RE: Inspection Report for West Spring Lake Road Bridge

We have completed our inspection of the West Spring Lake Road Bridge over Smith's Bayou (structure number 8941, aka "Smith's Bridge"). Our report follows:

EXISTING CONDITIONS – REVIEW OF APRIL 24, 2019 INSPECTION

Pier Defect Locations

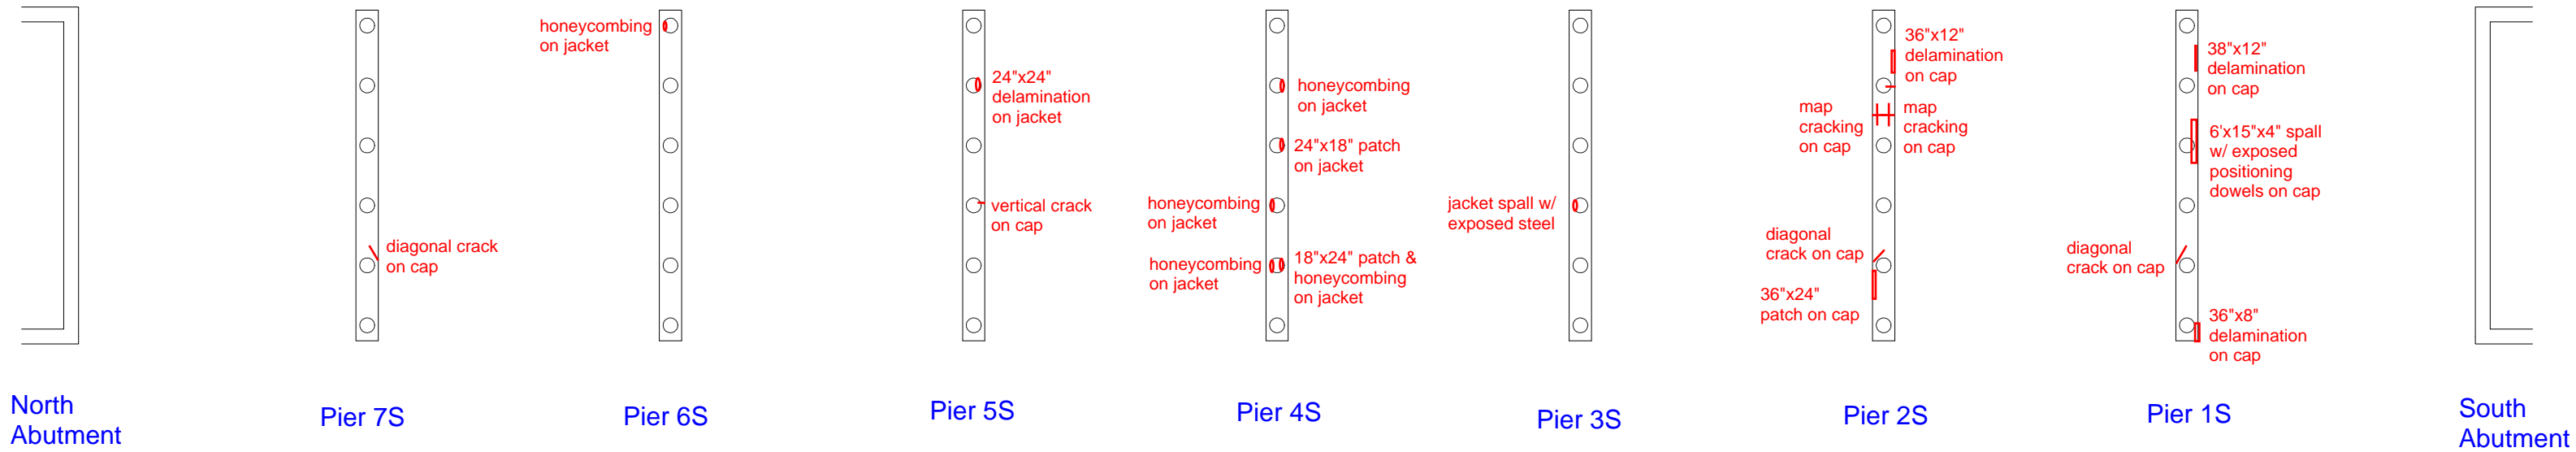
The piers consist of six (6) steel H piles with concrete jackets to protect against impact/corrosion and concrete caps to connect the piles and provide a uniform bearing area. The concrete jackets were repaired and supplemented with fiber reinforced polymer (FRP) wraps in 2008. On the concrete pile jackets, we noted vertical cracking on the order of 1/16" on many of the original jackets, scattered honeycombing and spalling with exposed reinforcing steel. On the concrete pile caps we noted evidence of heavy leakage at the utility chases, minor to moderate leakage at box beam joints, scattered cracking and delamination. We noted a severe spall with exposed positioning dowels and undermined bearings on the south face of Pier 1S at Beam 9W and beyond. A figure illustrating specific comments referenced by location is included as Attachment 5.

The piers were rated as 6 in 2014, reduced to 5 in 2016 which the MDOT QC inspector agreed with in 2017, and reduced again to 4 in 2018. The underwater inspection in 2017 rated the portion of the piers below the water line as a 5. The guidance for a rating of 5 is "Moderate delamination, spalling or efflorescence. Reinforcement exposure without section loss. Moderate deterioration affecting structural components including minor settlement, shallow scour, or impact damage." The guidance for a rating of 4 is "Considerable cracking, spalling, and efflorescence with heavy build-up or rust staining. Considerable deterioration affecting structural members including partial settlement or scour. All members continue to function as designed." Based on the severity of the spalling on Pier 1S, we concur with the rating of 4.

STRUCTURAL CONCRETE OVERLAY CONCEPT
NOT TO SCALE

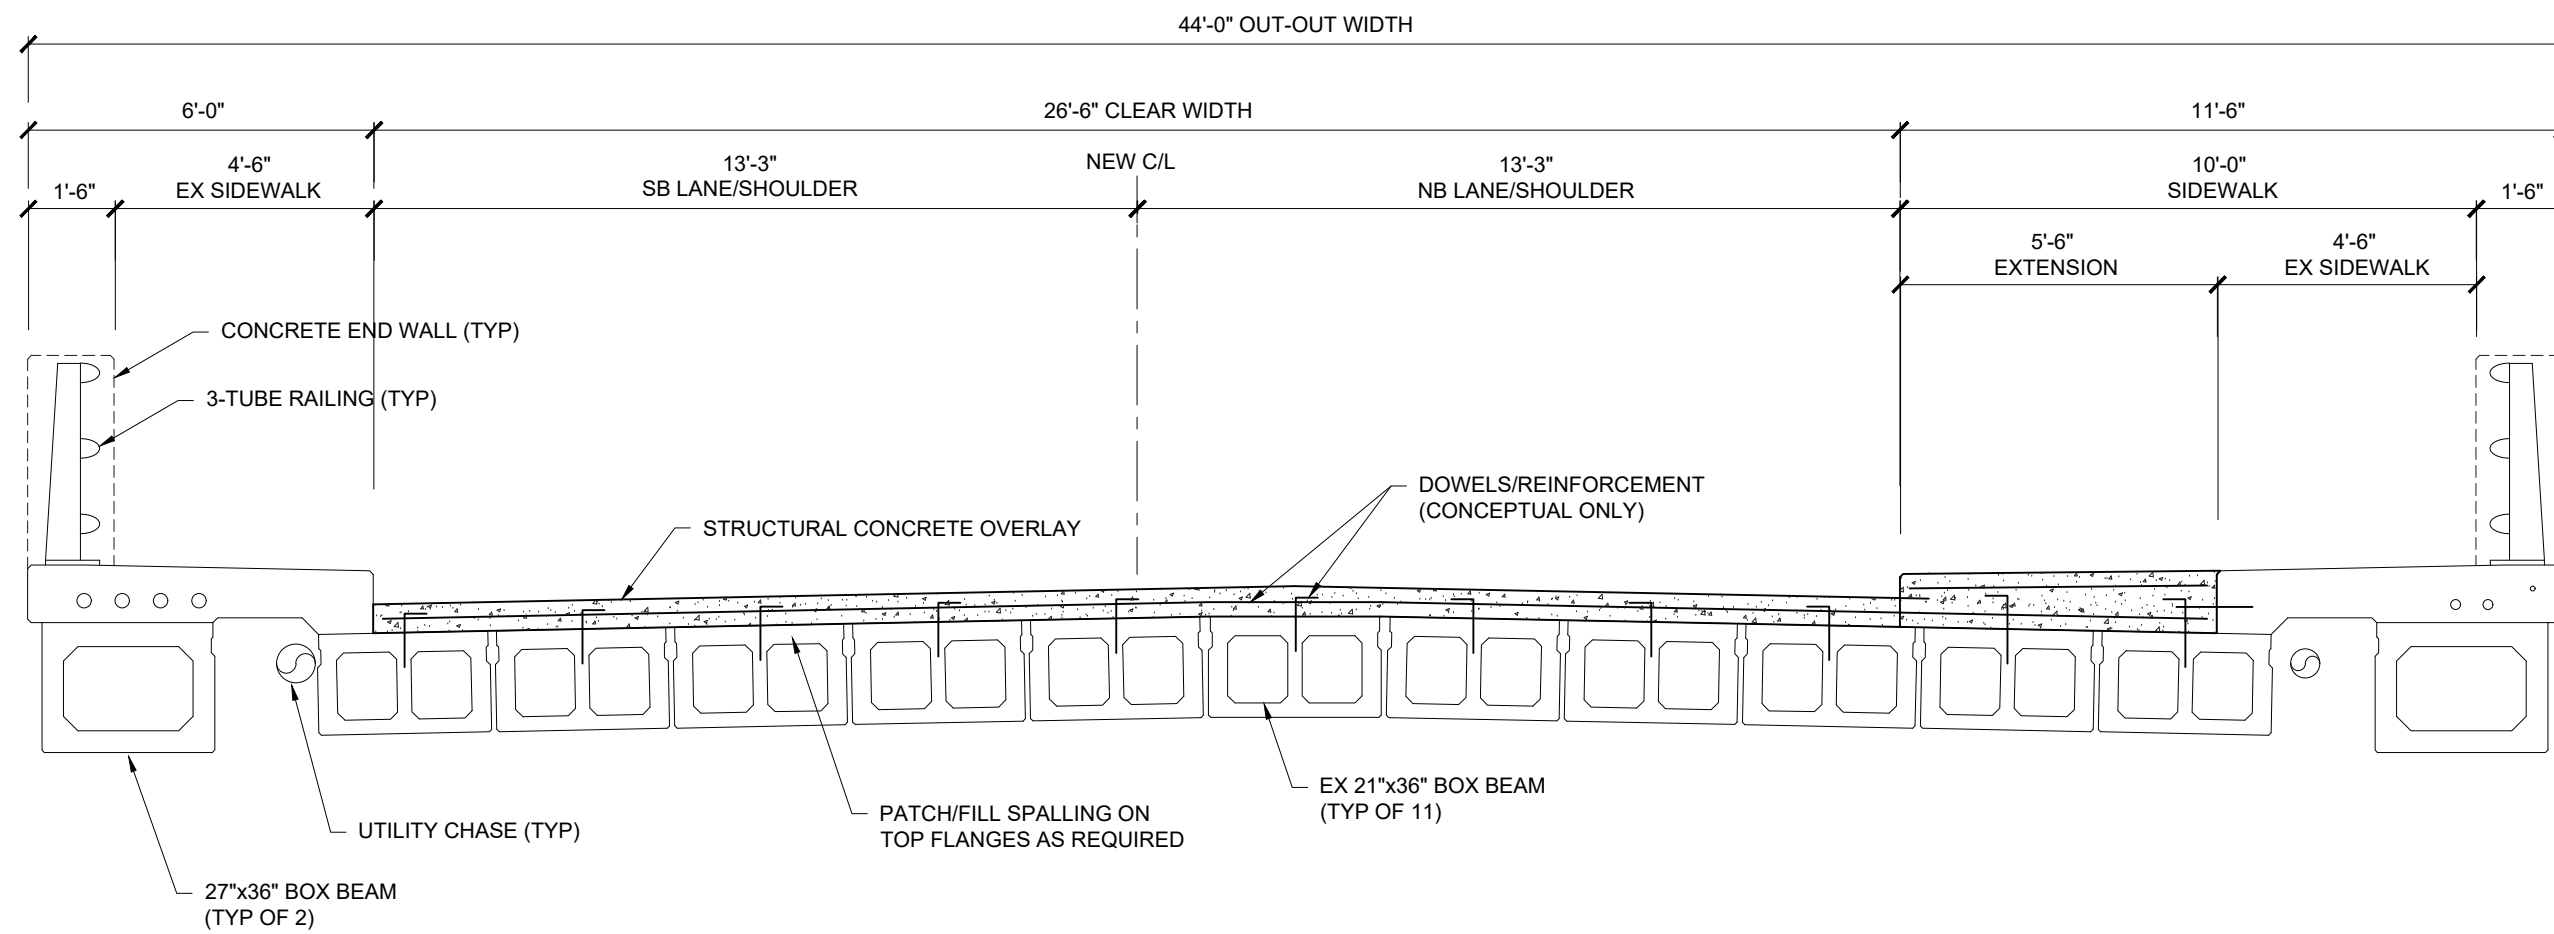
In this alternative, the asphalt wearing surface would be removed, along with any unsound concrete from the tops of the box beams. Steel reinforcement dowels would be installed in the box beams to connect them structurally with a new concrete overlay/deck. This would increase the structural capacity of the beams to offset the additional dead load and all but eliminate the chances of a hole developing. We would view this as a 15 to 20-year solution. A figure illustrating this concept is included as Attachment 6.
